# RENESAS TECHNICAL UPDATE

Product Category	MPU/MCU		Document No.	TN-RX*-A0230A/E	Rev.	1.00
Title	Errata to User's Manual: Hardware Regarding the I <sup>2</sup> C-bus Interface (RIIC)		Information Category	Technical Notification		
Applicable Product	RX110 Group, RX111 Group, RX113 Group, RX23T Group, RX634 Group	Lot No.	Reference Document	User's Manual: Hardware for applicable products (see the table at the last page)		
		All

This document describes corrections to the “I<sup>2</sup>C-bus Interface (RIIC)” chapter in User's Manual: Hardware for the applicable products.

Figure 24.28 Set/Clear Timing of the AASy and DID Flags during Reception of Device-ID Address

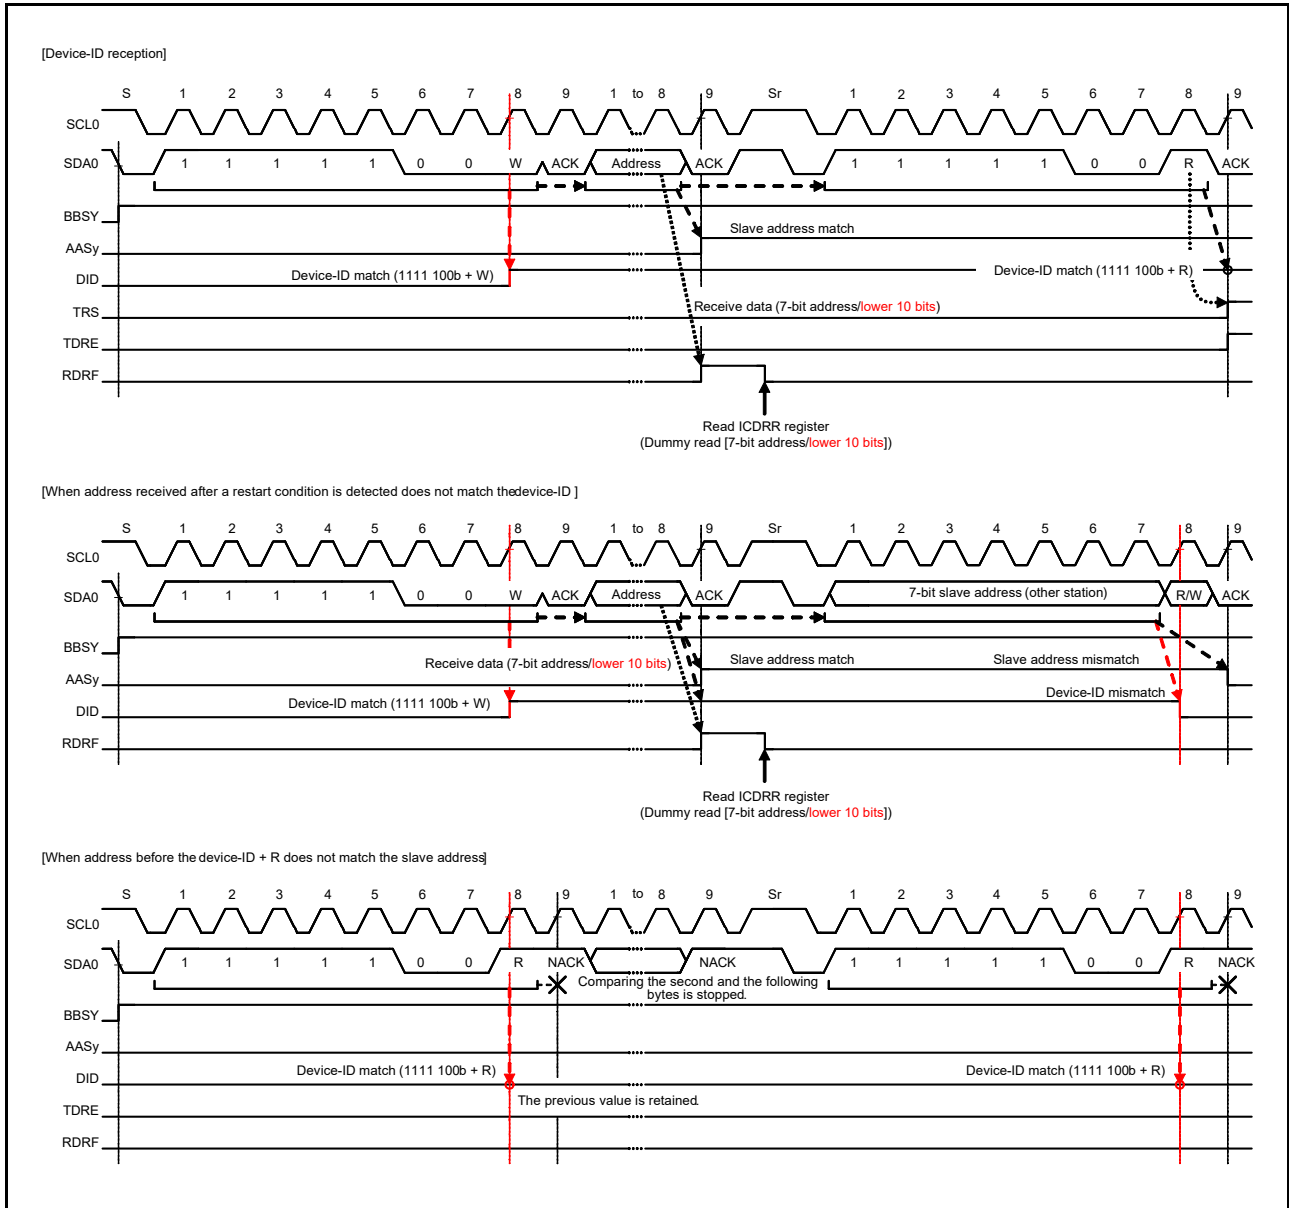
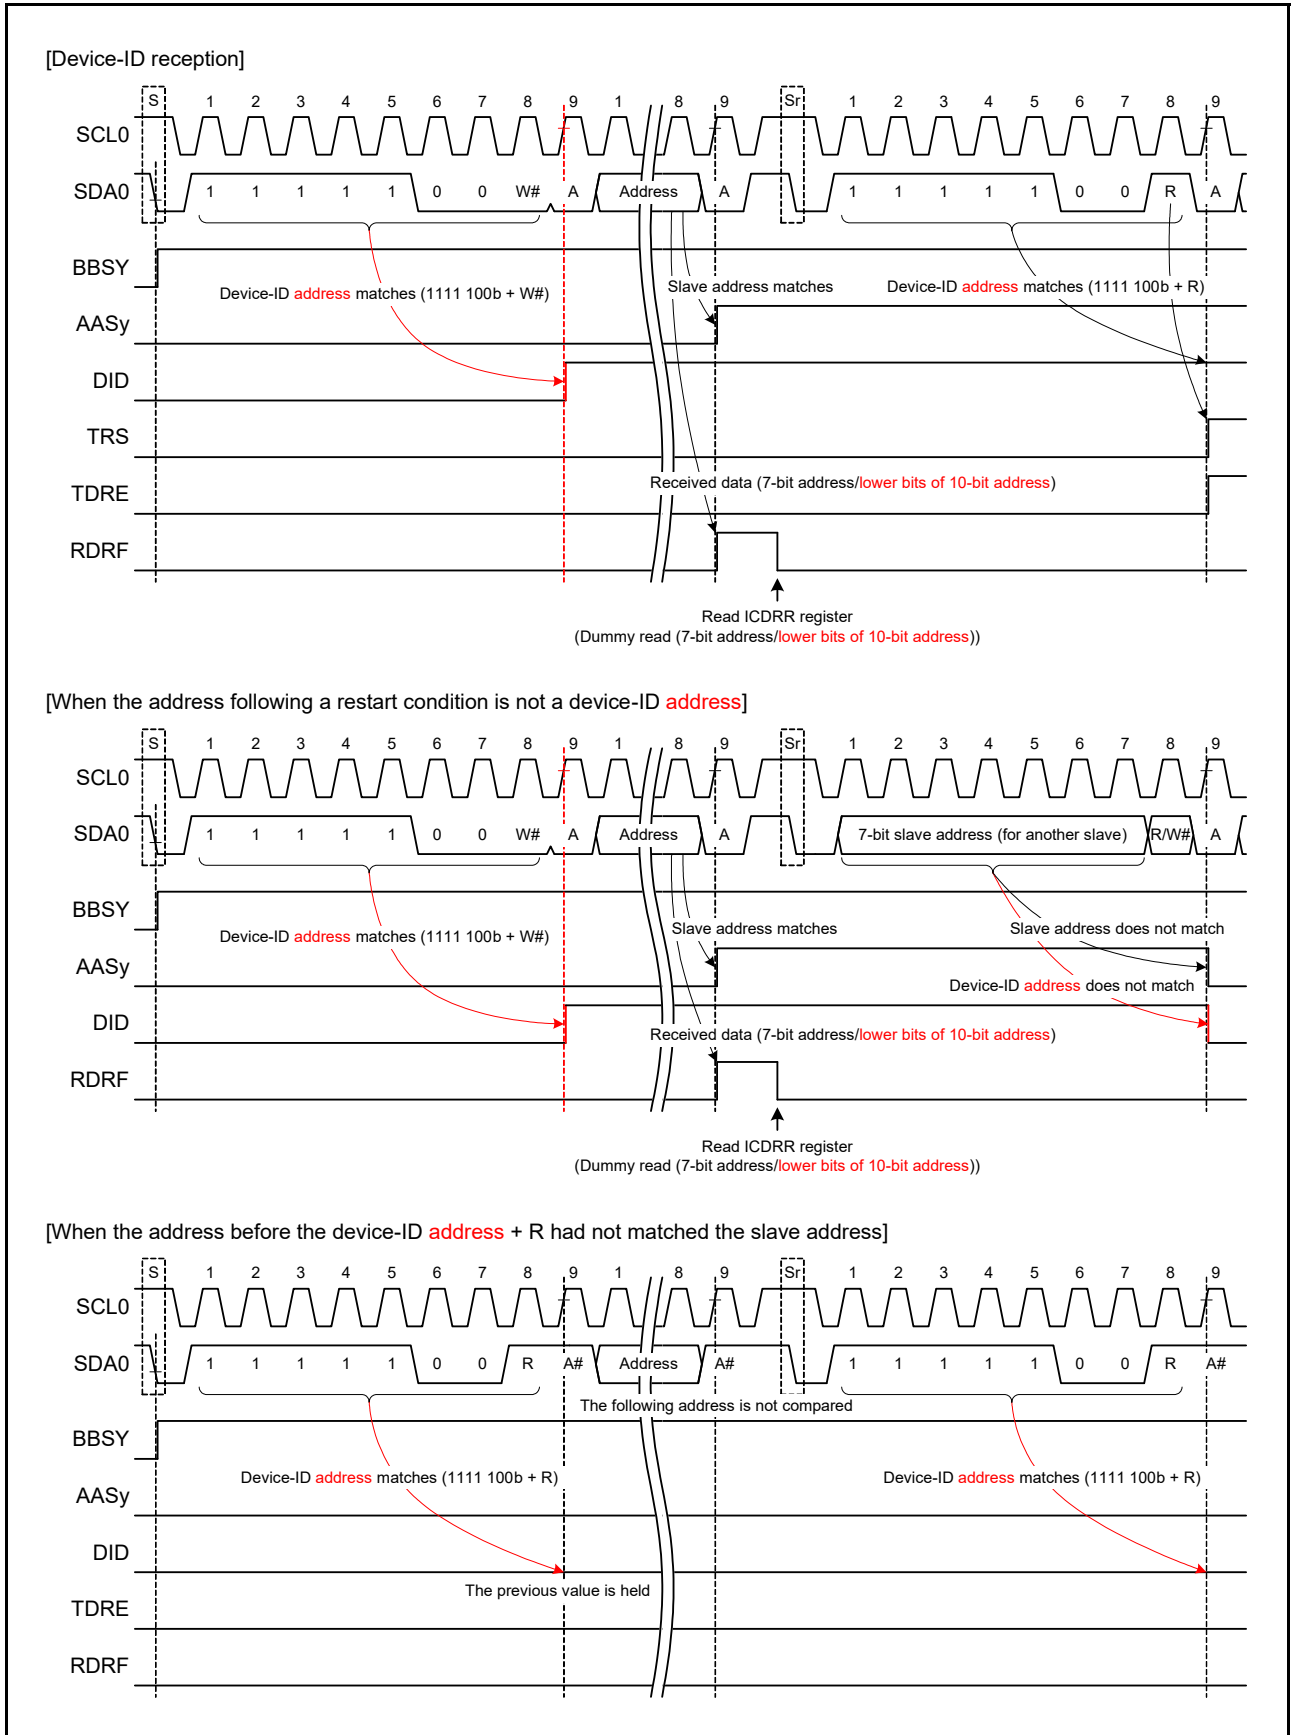
Figure 24.28 in section 24.7.3, Device-ID Address Detection is corrected as follows.

Figure 24.31 Suspension of Data Transmission When NACK is Received (NACK = 1)

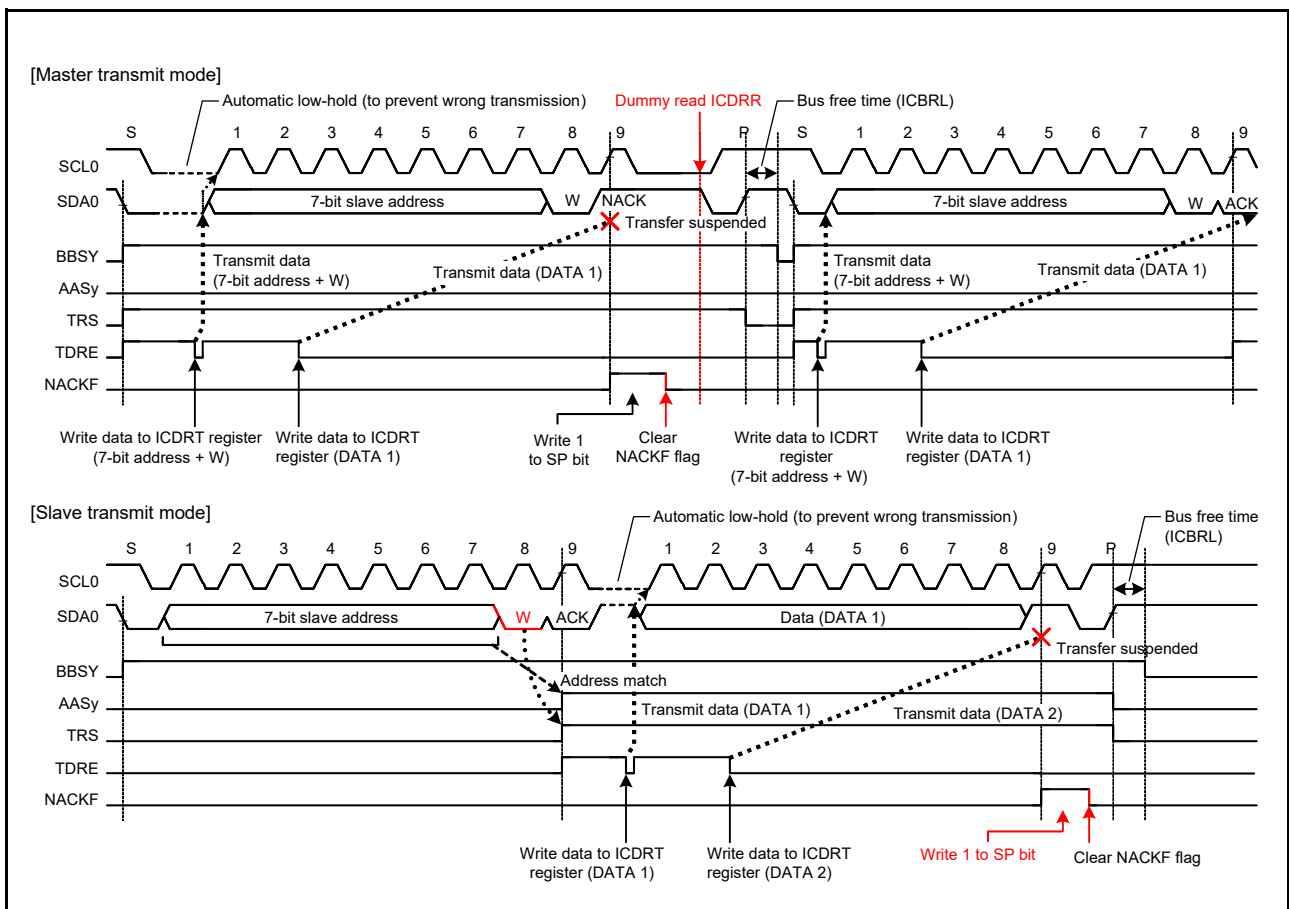
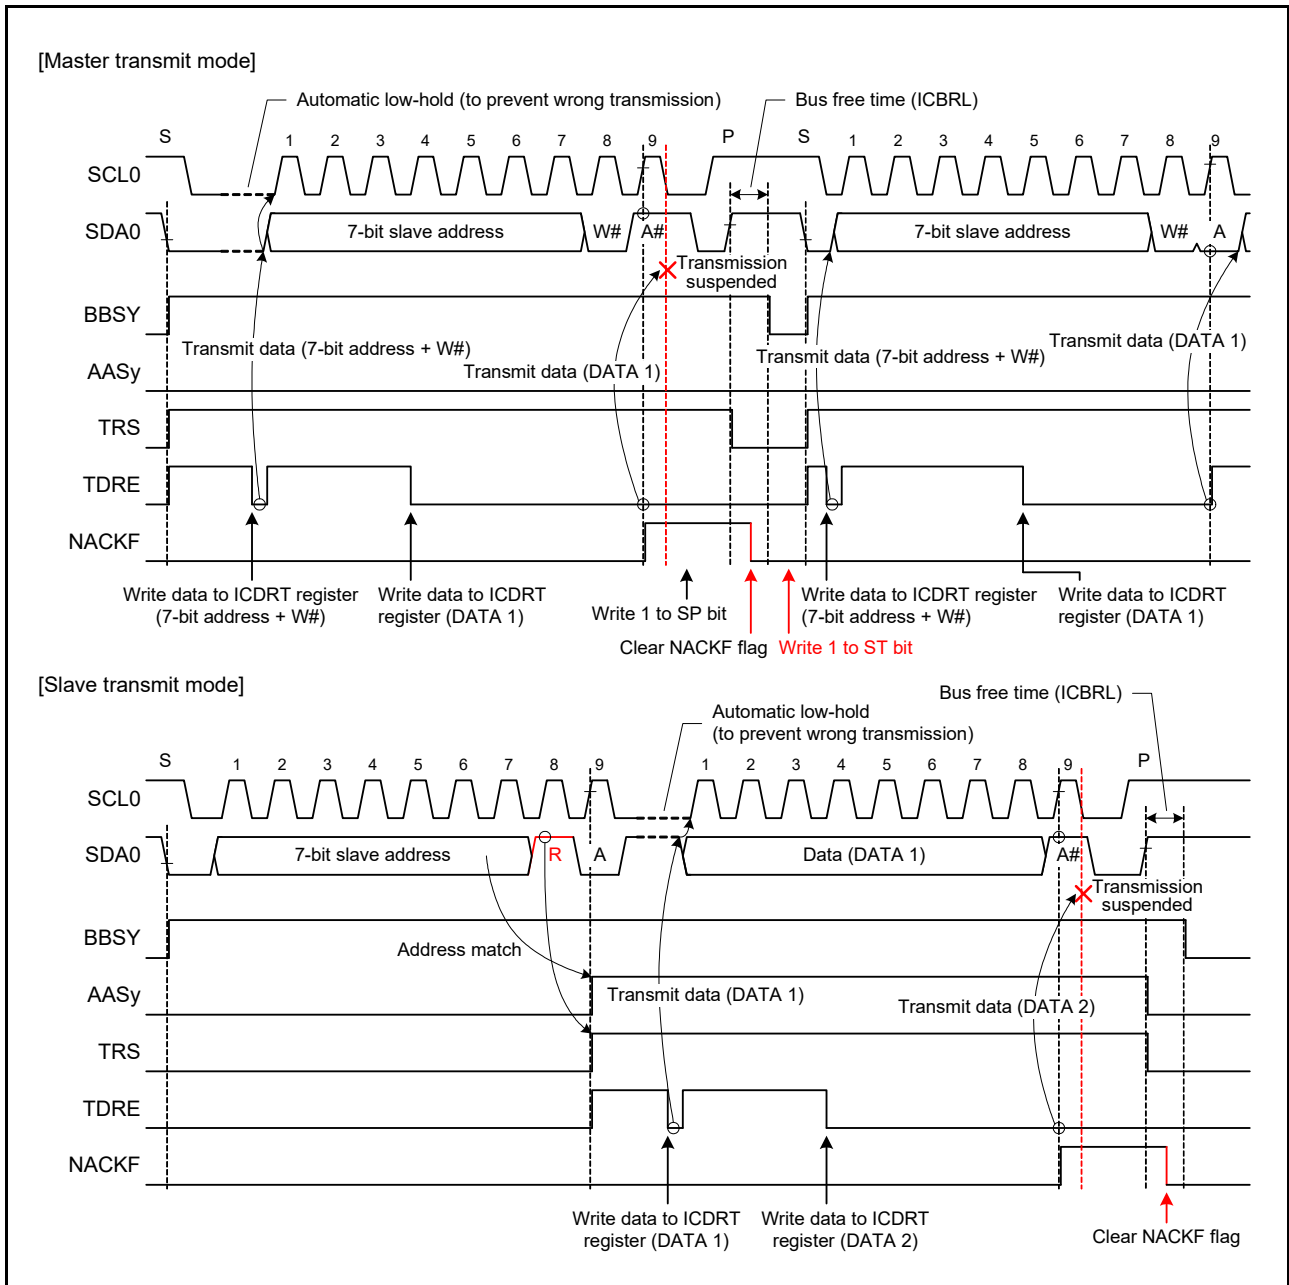
Figure 24.31 in section 24.8.2, NACK Reception Transfer Suspension Function is corrected as follows.

**Figure 24.40 Additional SCL Output Function (CLO Bit)**

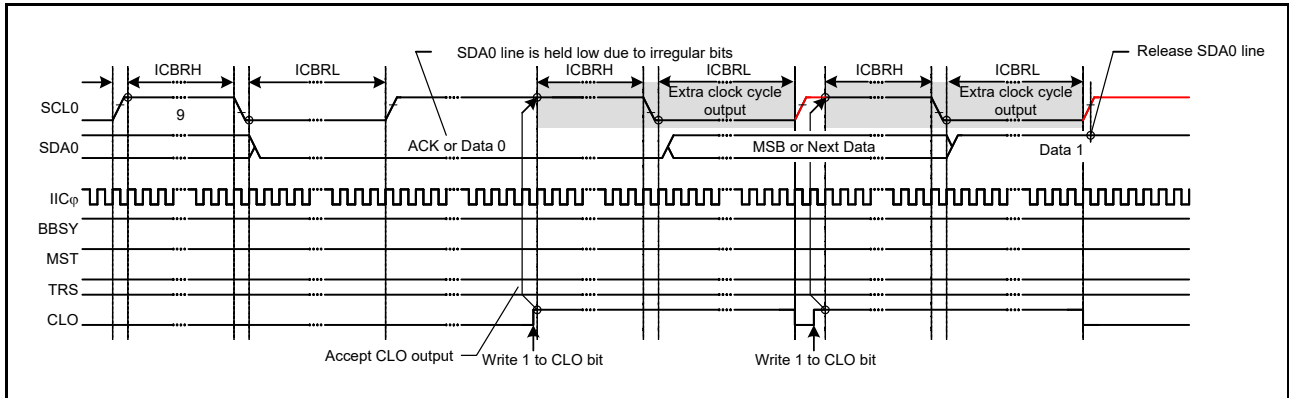
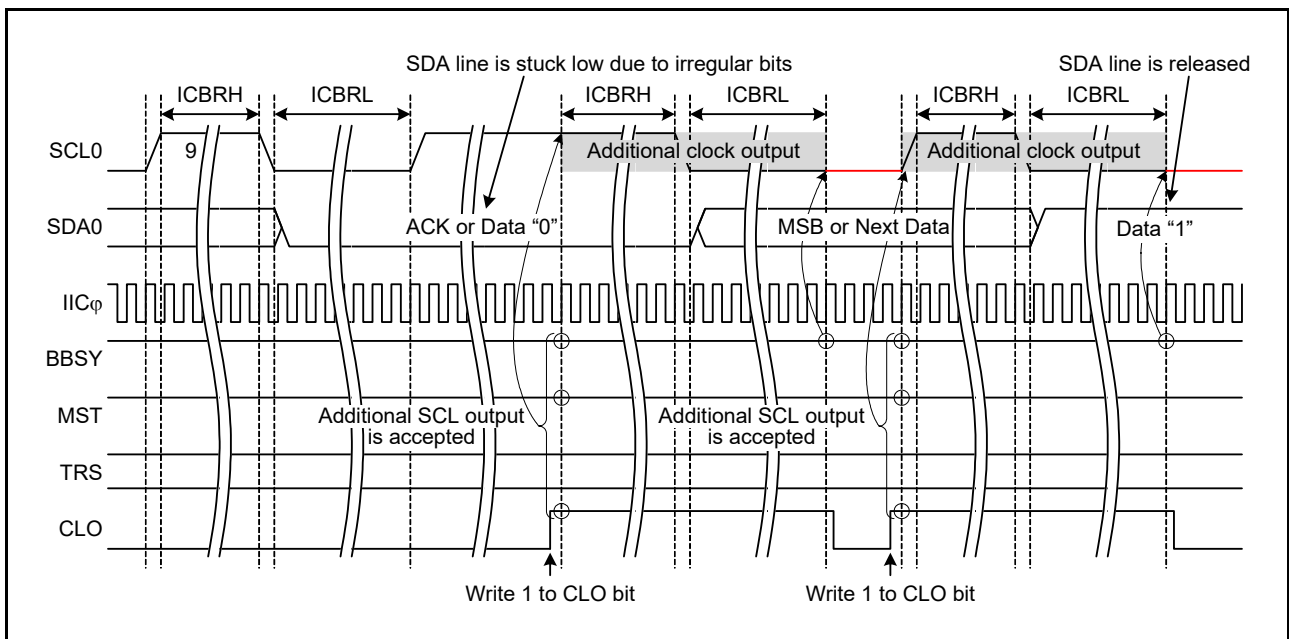
Figure 24.40 in section 24.11.2, Extra SCL Clock Cycle Output Function is corrected as follows.
